Platform 5
architects

21-102 | Brentwode

Section 73 Planning Statement
March 2025

1.1 Proposal Overview

Approved ground floor plan

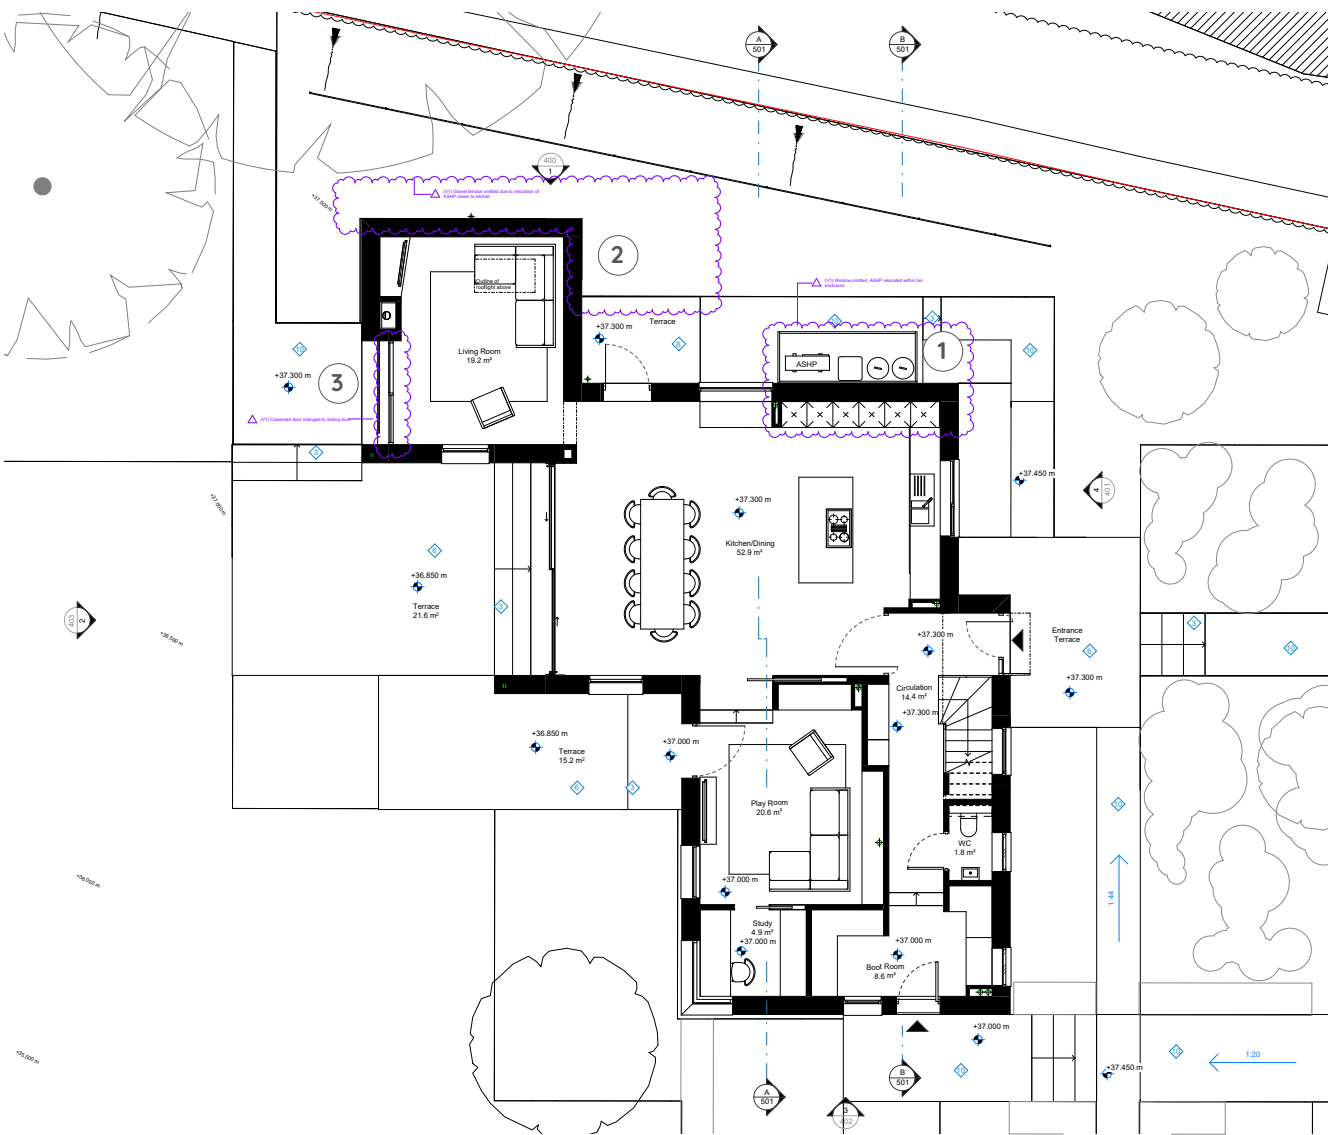
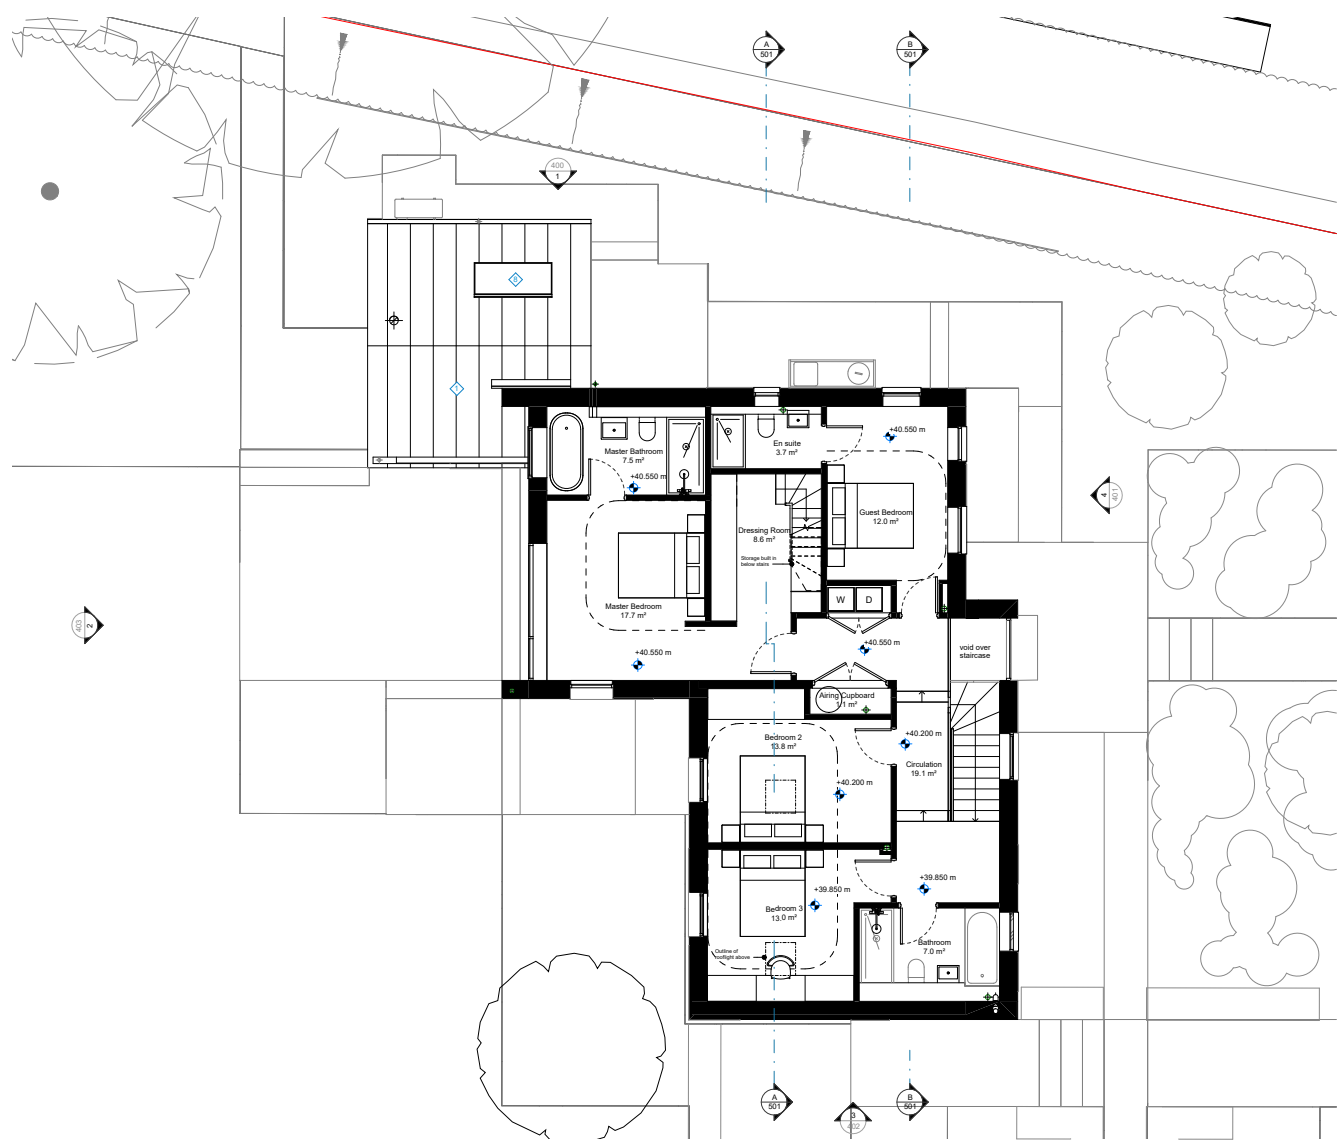
- 1. omission of a north-facing kitchen window
- 2. re-location of the ASHP
- 3. change from a casement glass door with fixed side panel on the south elevation to a sliding glass door
- 4. change in design of the living room rooflight
- 5. addition of an opening roof window above the hallway
- 6. addition of a 25 panel solar photovoltaic array

Approved first floor plan

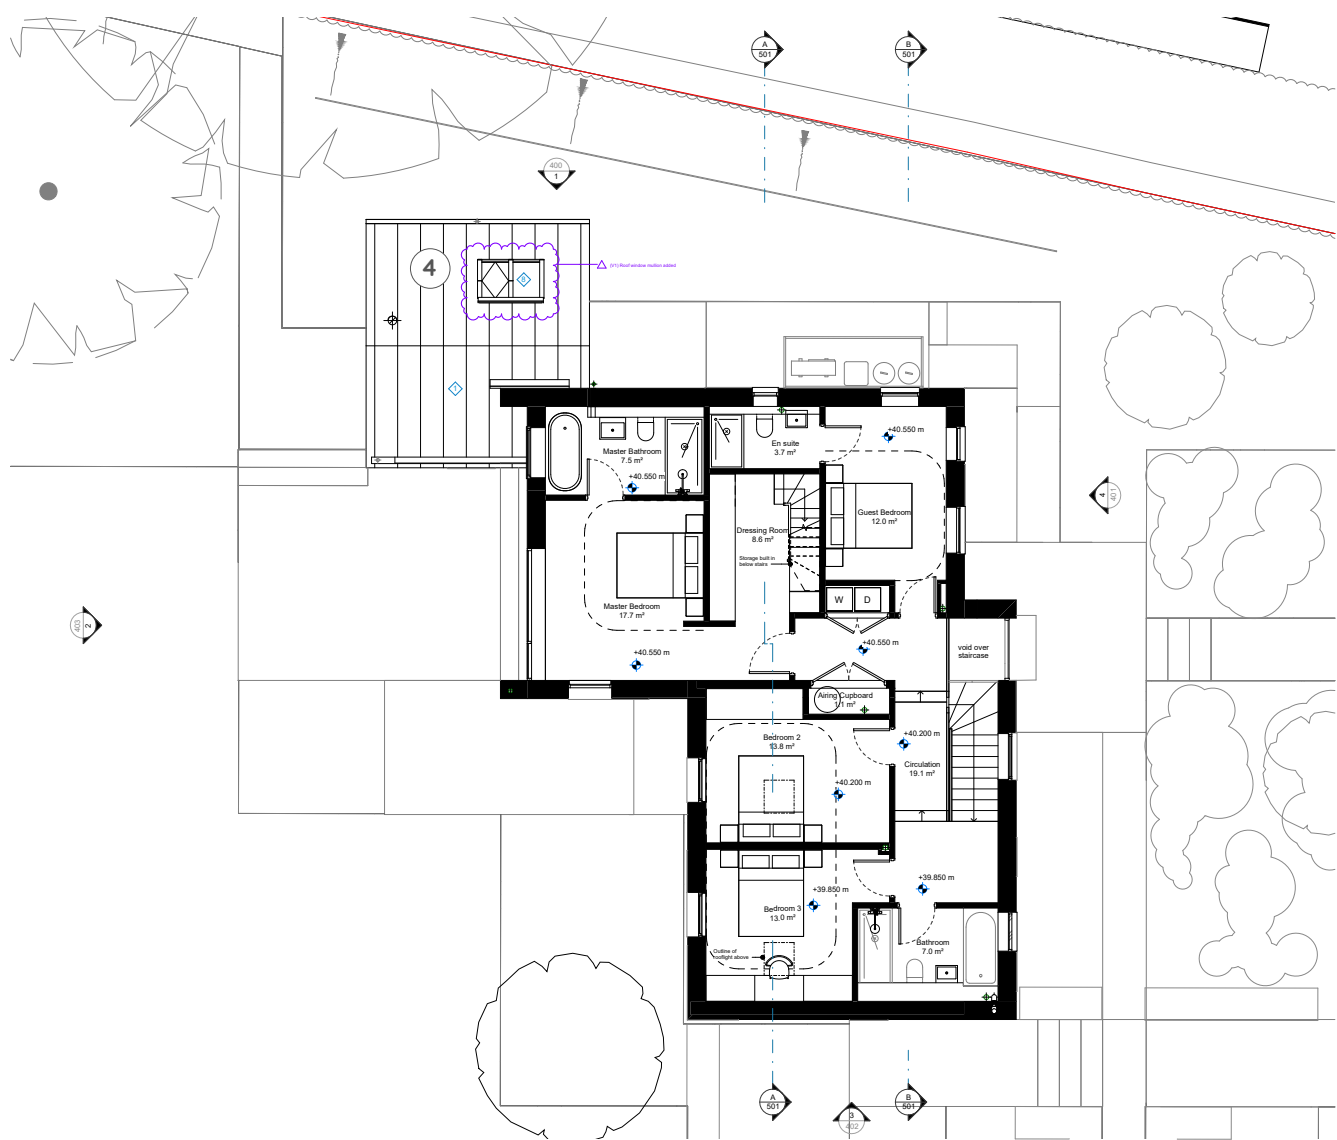
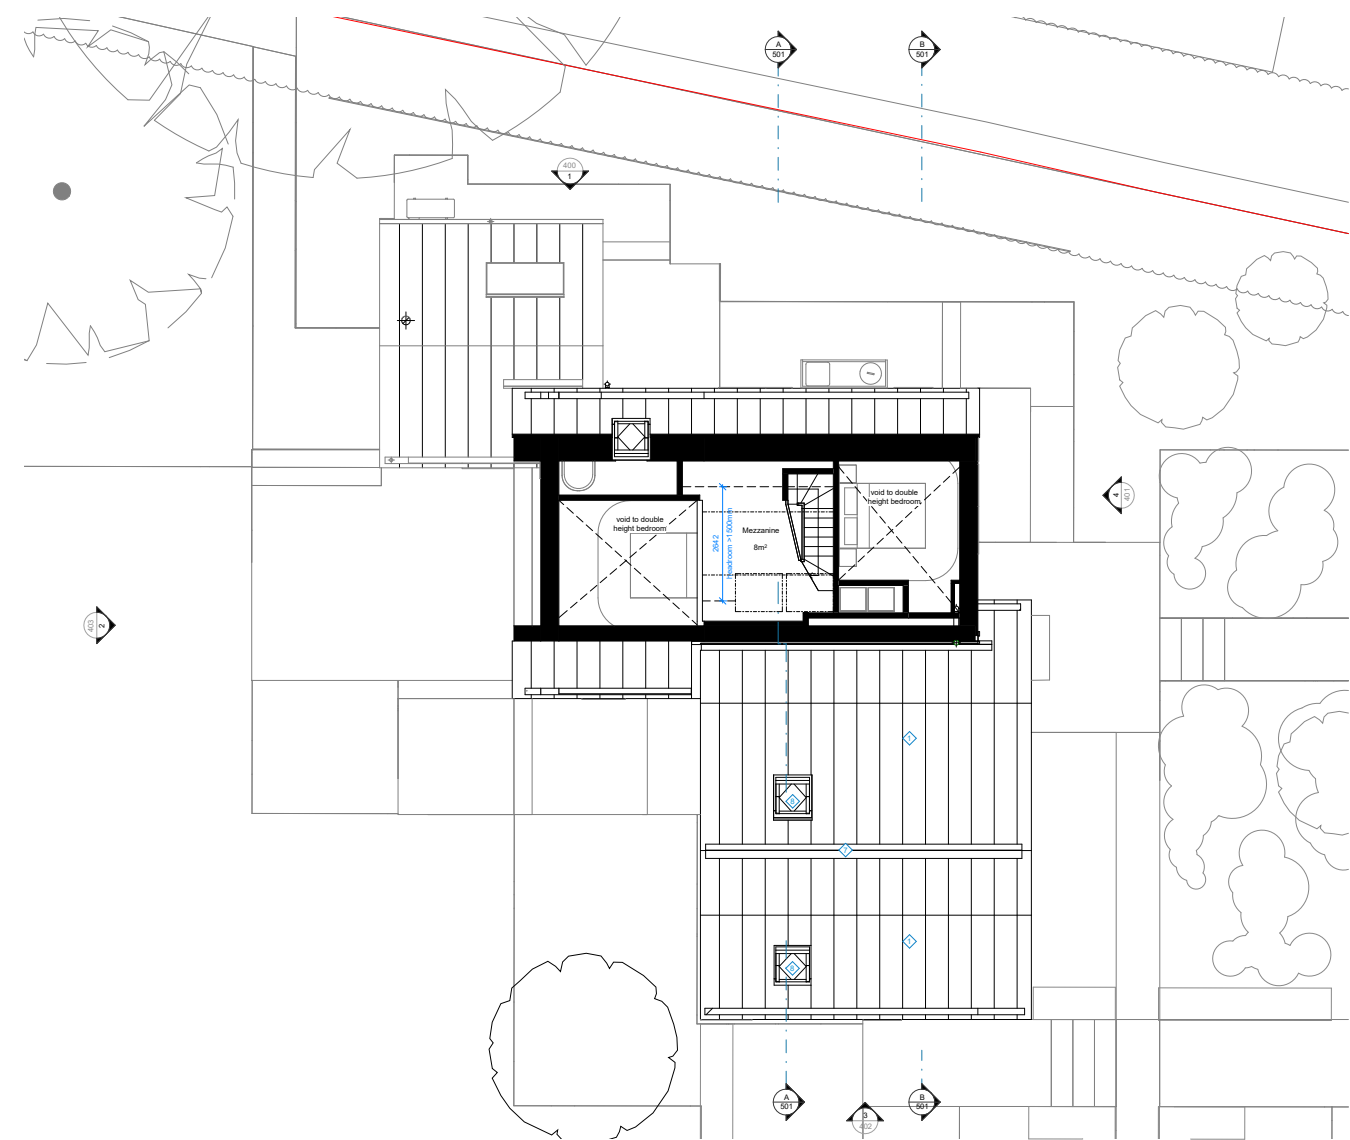
- 1. omission of a north-facing kitchen window
- 2. re-location of the ASHP
- 3. change from a casement glass door with fixed side panel on the south elevation to a sliding glass door
- 4. change in design of the living room rooflight
- 5. addition of an opening roof window above the hallway
- 6. addition of a 25 panel solar photovoltaic array

Approved mezzanine plan

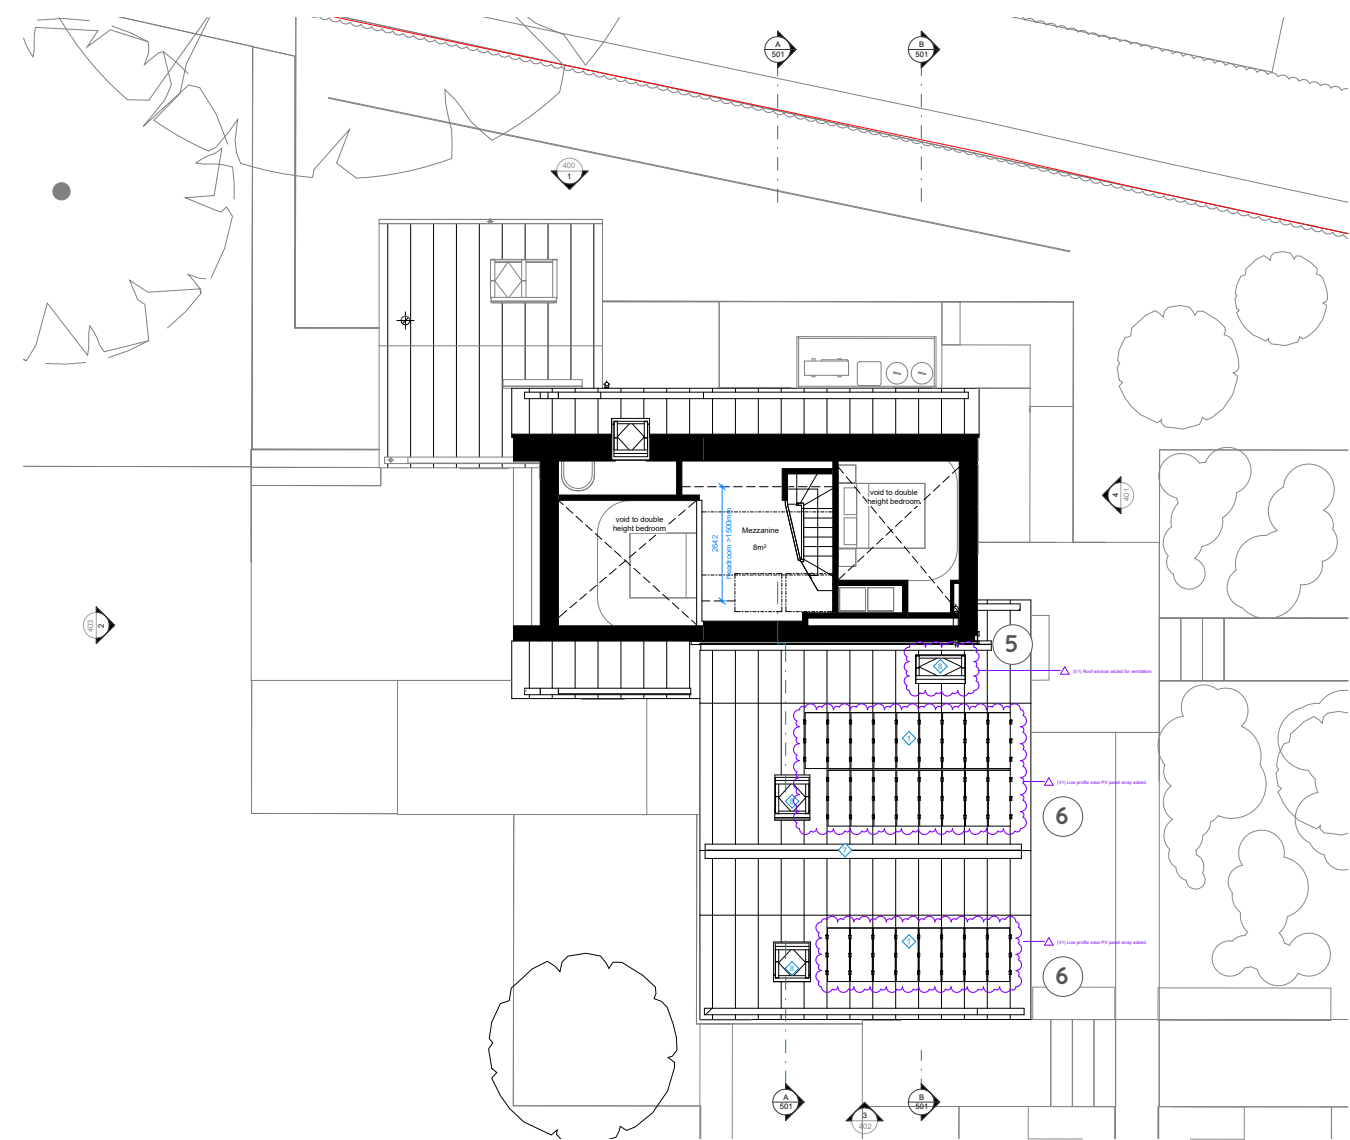
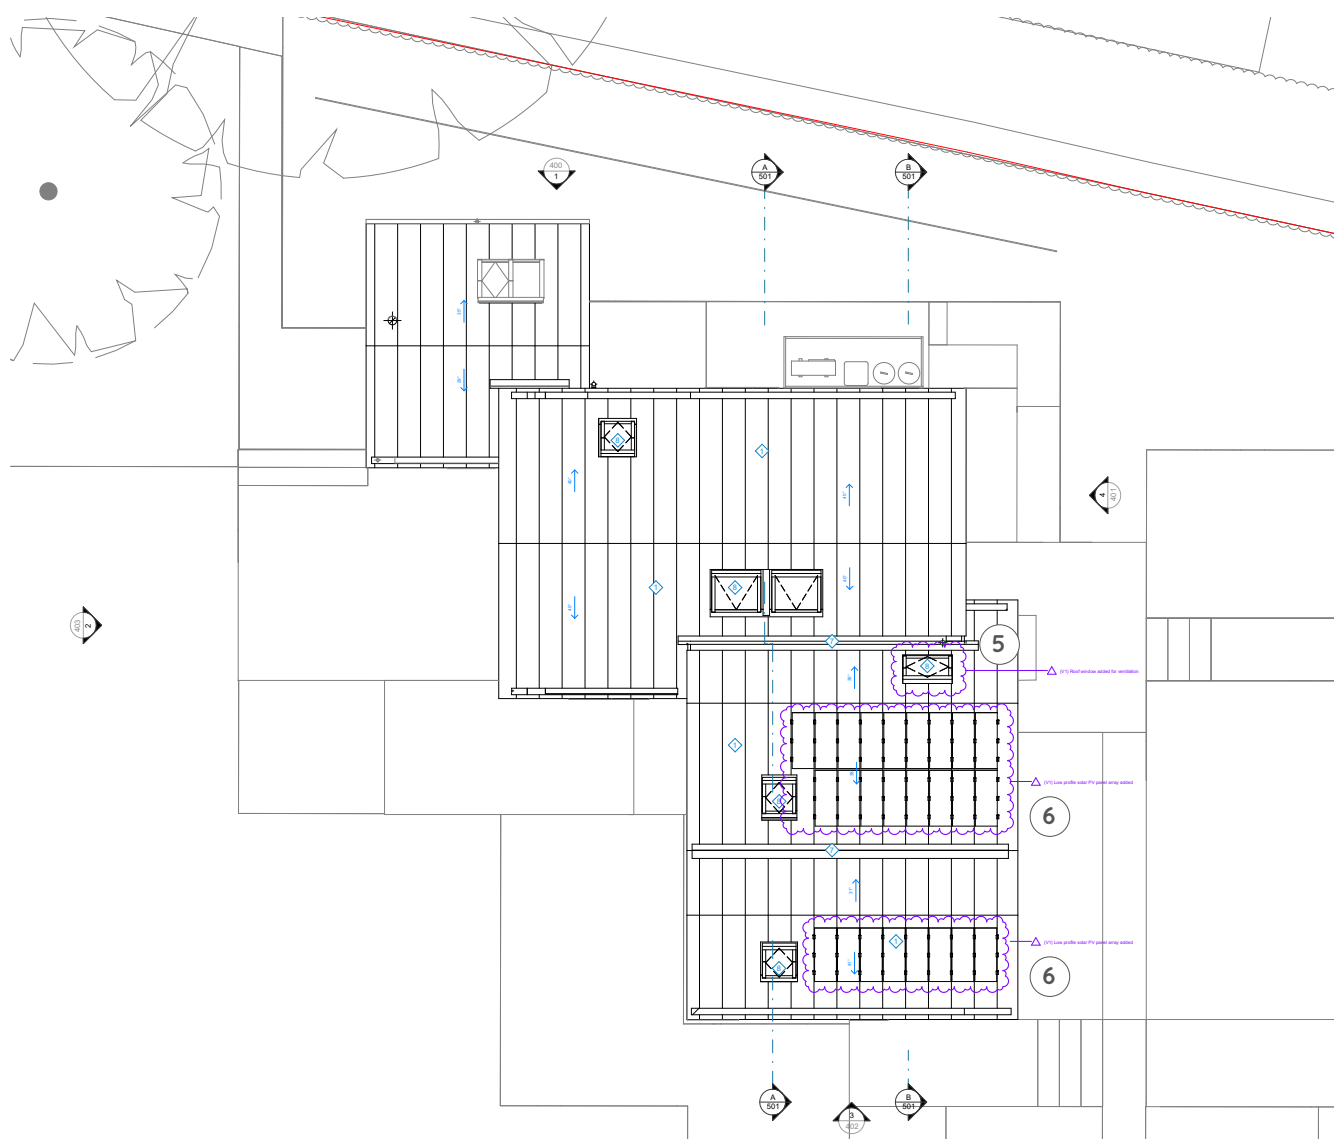
- 1. omission of a north-facing kitchen window
- 2. re-location of the ASHP
- 3. change from a casement glass door with fixed side panel on the south elevation to a sliding glass door
- 4. change in design of the living room rooflight
- 5. addition of an opening roof window above the hallway
- 6. addition of a 25 panel solar photovoltaic array
